RECEIPT DATE: 2-21-19 **ONSITE SEWAGE DISPOSAL SYSTEM** P 564767-A
 APPROVAL DATE: 5/22/19 **PERMIT: CONSTRUCTION** A _____
 PROPERTY ADDRESS: 13835 Mill Creek Court
 SUBDIVISION: Mill Creek LOT: 20 TAX ID: _____
 CONTRACTOR: South Carroll Backhoe EMAIL: Scbackhoe@comcast.net
 CONTRACTOR ADDRESS: 4410 Salem Bottom Road, Westminster, MD 21157 PHONE: 410-596-3618

From: Collins, Sarah
Sent: Monday, March 25, 2019 2:19 PM
To: 'Kristy Pierce'
Subject: Mill Creek lot 20 septic plan

LOW PRESSURE DISTRIBUTION SYSTEM CALCULATIONS

BUILDING PERMIT PLOT PLAN

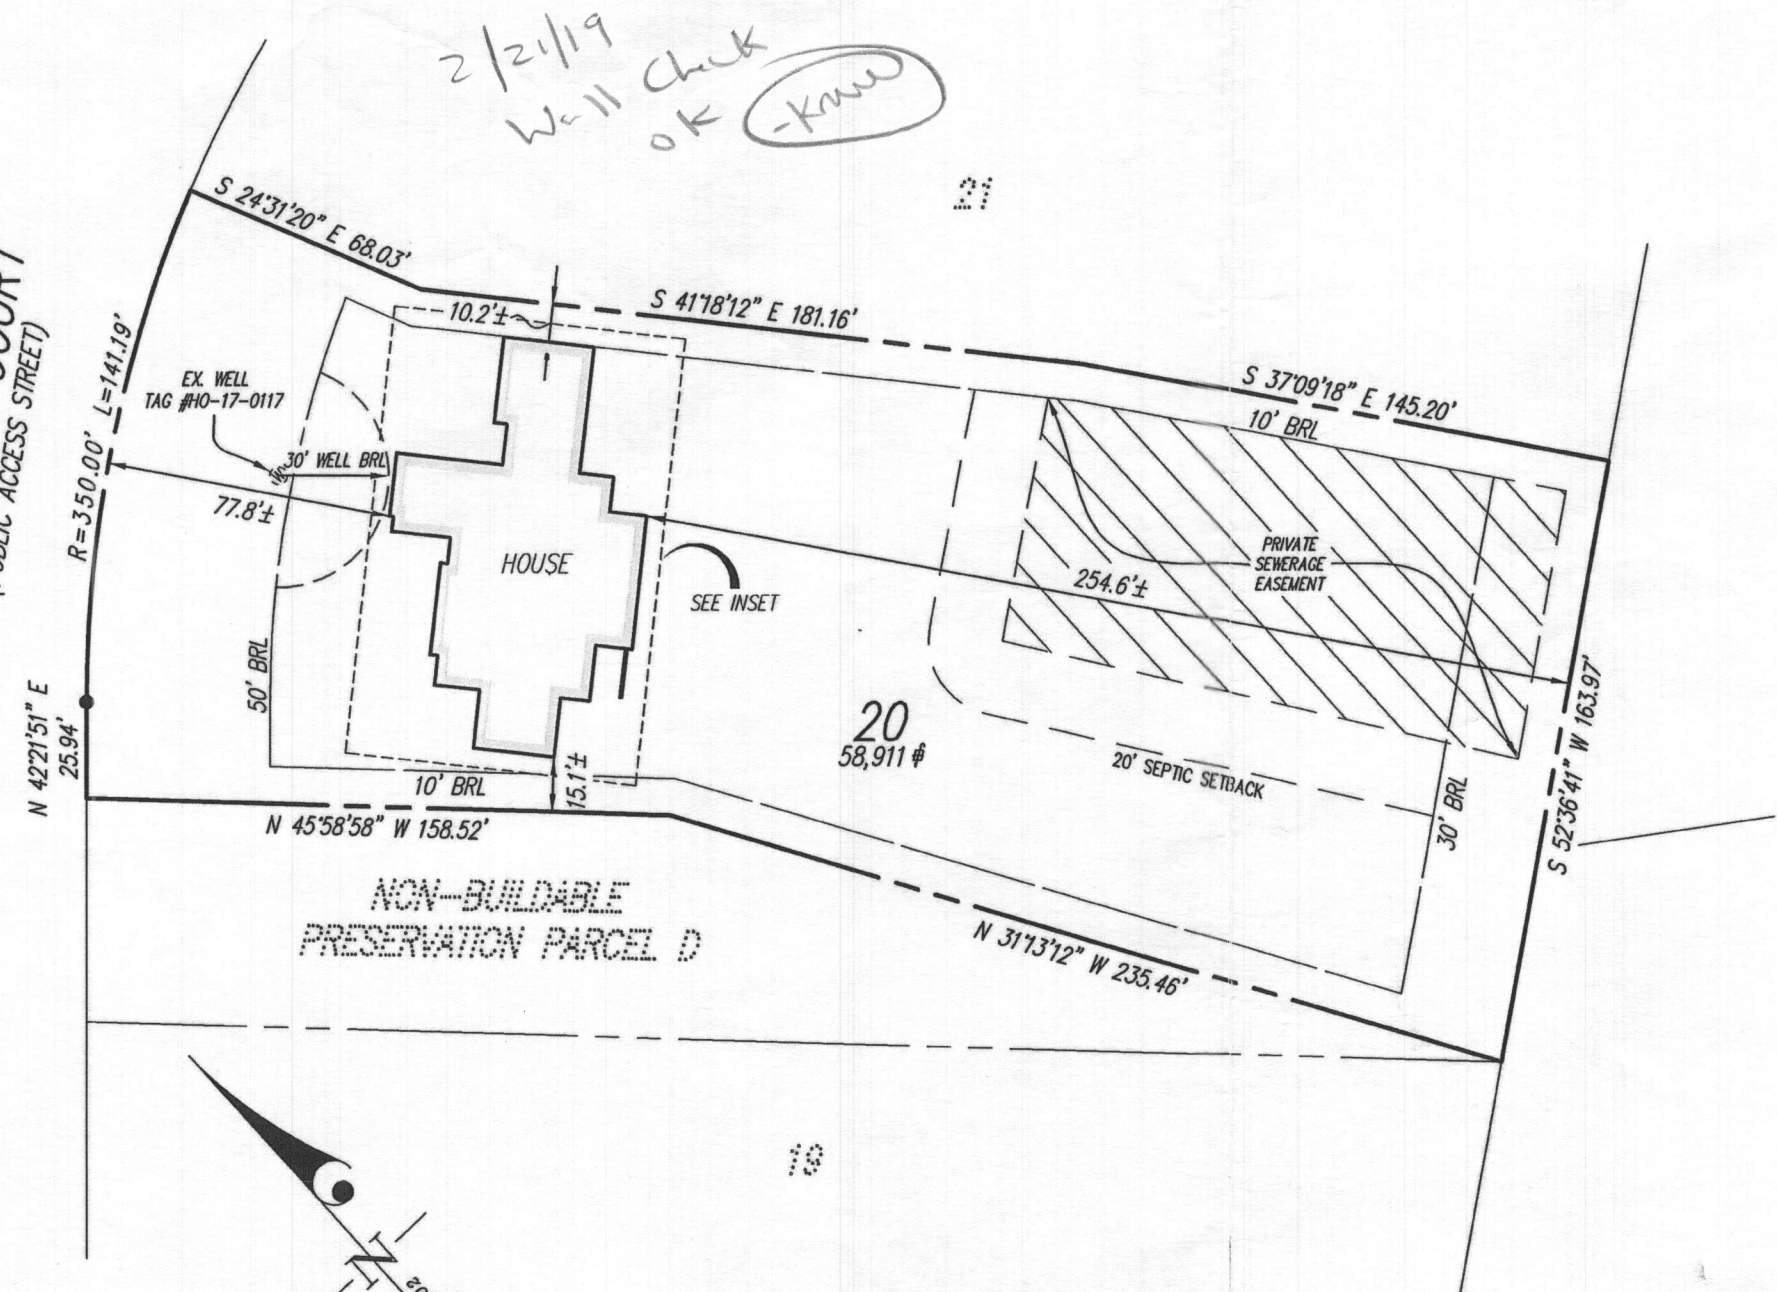
I met with the septic contractor for the layout at Mill Creek lot 20 and we noticed that the plan has a center feed trench with the first hole where the manifold meets the lateral (odd # of holes for a center feed system). We propose the contractor lowers the elevation of the upper trench to be the same at the lower trench. Here are the changes in the table of calculations on the plan (shown in red):

The septic plan for Mill Creek lot 20 is another low pressure dosed system that will need some bends in the force main. Specifically, the line will need 2x45 degree bends from the pump tank near the lower septic corner and 2x45 degree bends when it turns to go into the manifold. Also, the pump may be undersized per the pump curve shown on the plan. Can you do the calculations to include 4x45 degree bends and determine which size pump is needed?

Trench	Trench length (ft)	Feed	Pipe Inv. Elev (ft)	Head (ft)	Hole Diam. (in)	Hole Flow Rate (gpm)	Hole Spacing (ft)	Number of Holes	Trench Flow Rate (gpm)	Lateral Length (ft)	Flow (gpm) per LF Trench	Gal per LF Trench	Lateral Diam (in)	Type
1	43.5	End	465.6	2.0	5/16	1.63	5.44	8	13.04	40.78	0.299		1.5	SCH 40
2	87	Center	465.6	2.0	5/16	1.63	5.44	16	26.08	81.56	0.299		1.5	SCH 40

I didn't fill in the gal per LF of trench- I believe this depends on the pump run time, and the pump changed to a WE07H pump. Let me know if that looks alright.

See attached spreadsheet updated to include 4 45 degree bends... It looks like a WE07H pump will be needed. Thank you for checking this.

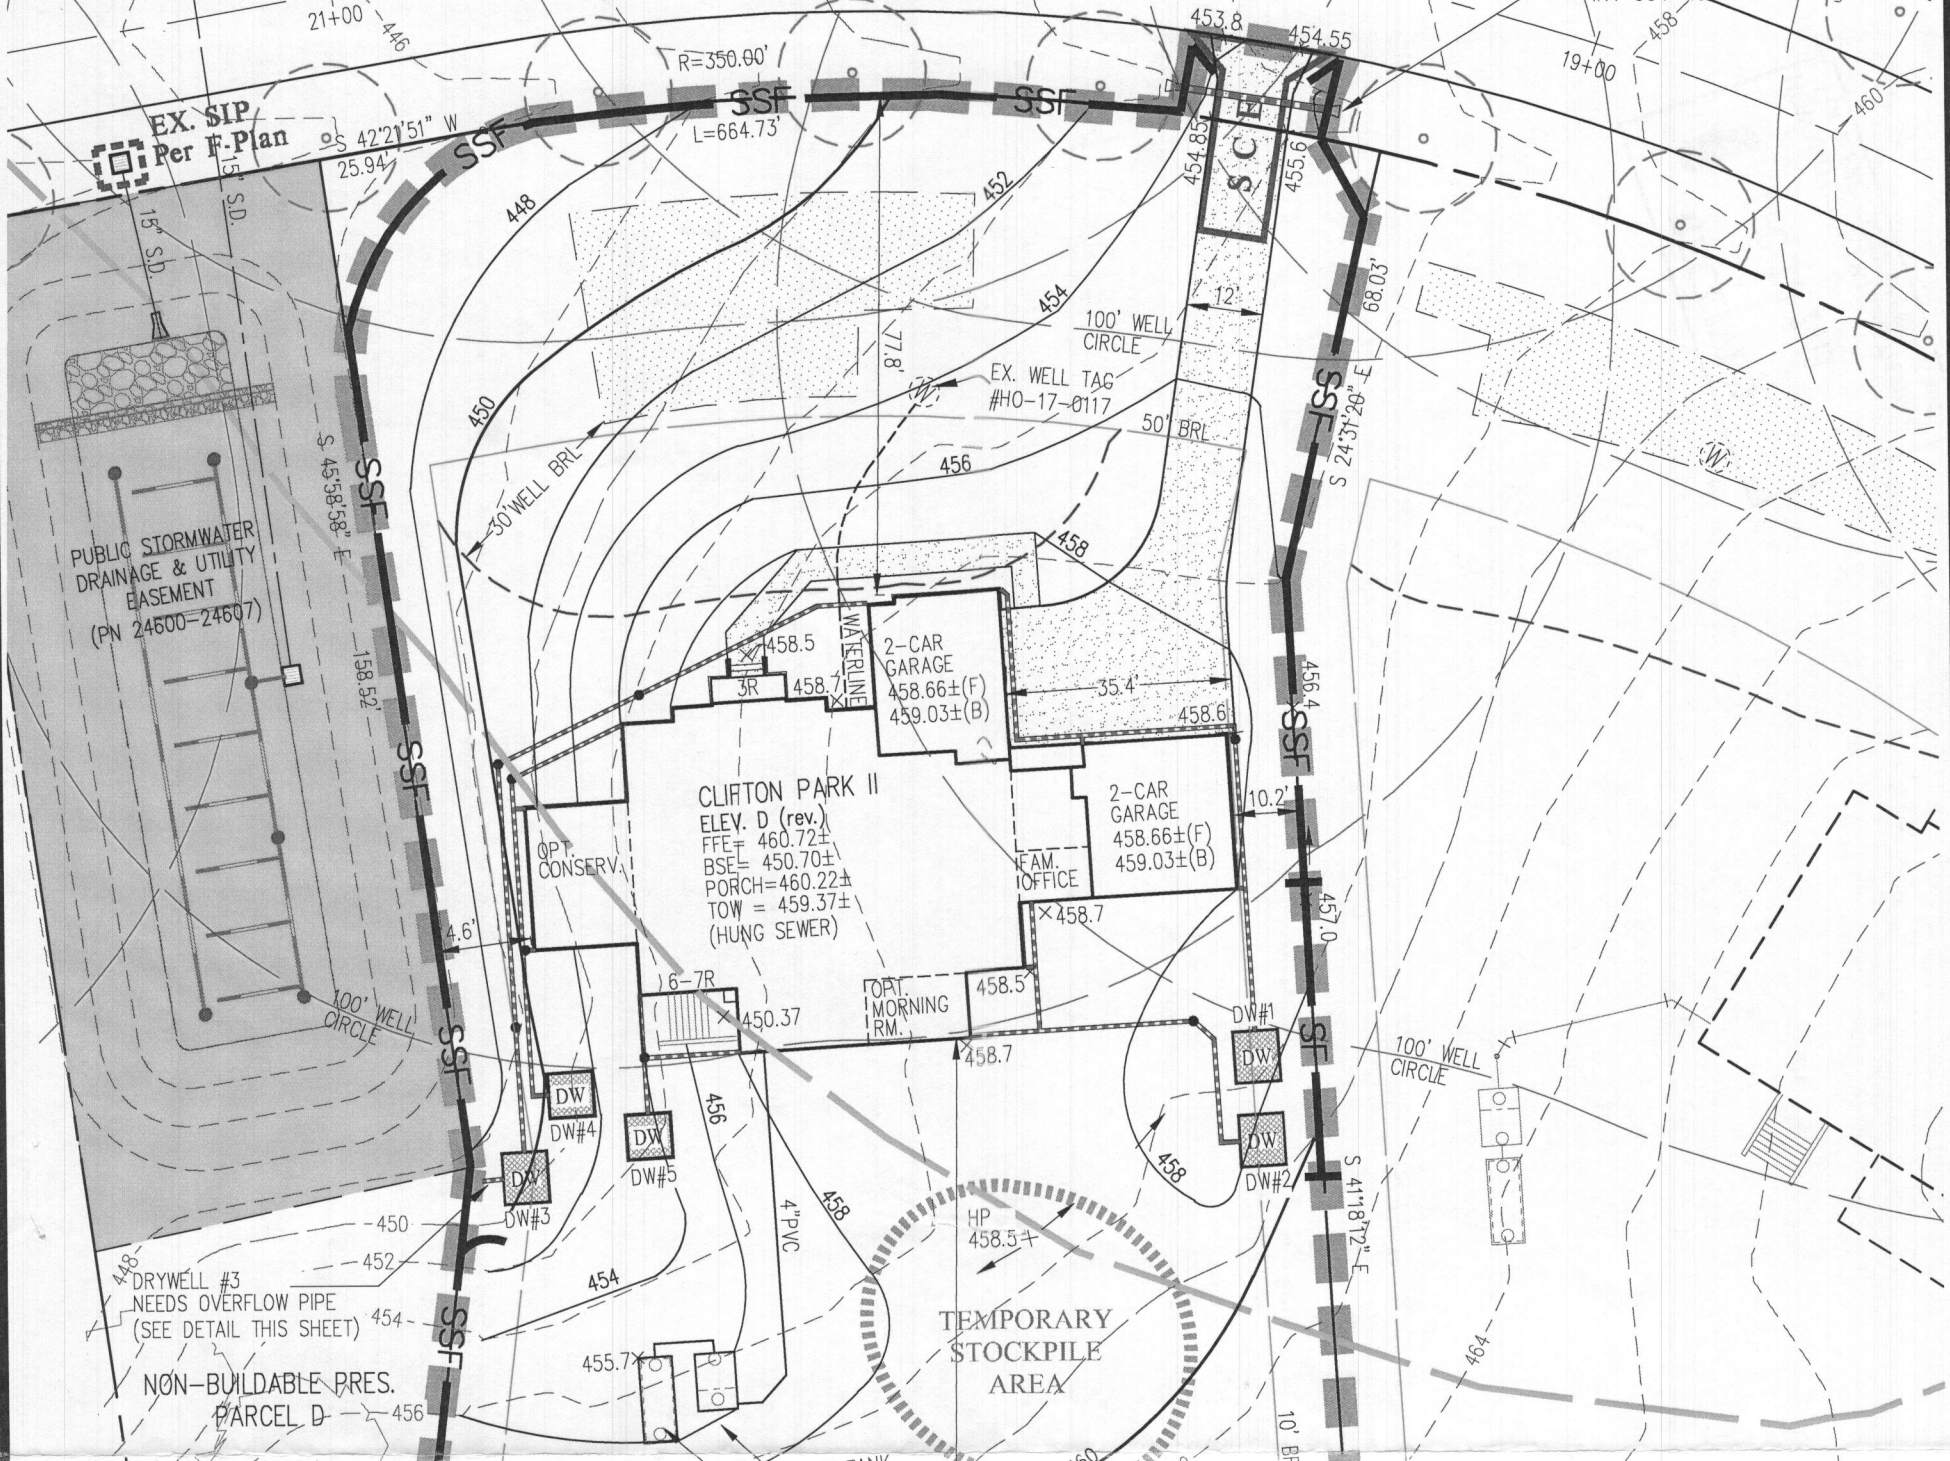
3/25/19 Met S. Carroll on site for layout. SDA corners, trenches, and tanks staked. Shot elevations of trench ends - within a few inches. Sewer line will be deep coming through basement wall - builder came by and the plumber can raise the sewer line 8". Also OK to turn tanks to reduce cover on tanks. Set tanks parallel to street no closer than stakes to keep setback from drywells. Plan shows 1" hole at manifold of T2 lateral - must change hole spacing. (SC)

We met with the builder and turned the tanks so they're parallel with the road but not any closer to the house. The change was to reduce cover to 3' or less over the tanks. The builder wanted me to let you know about the change.
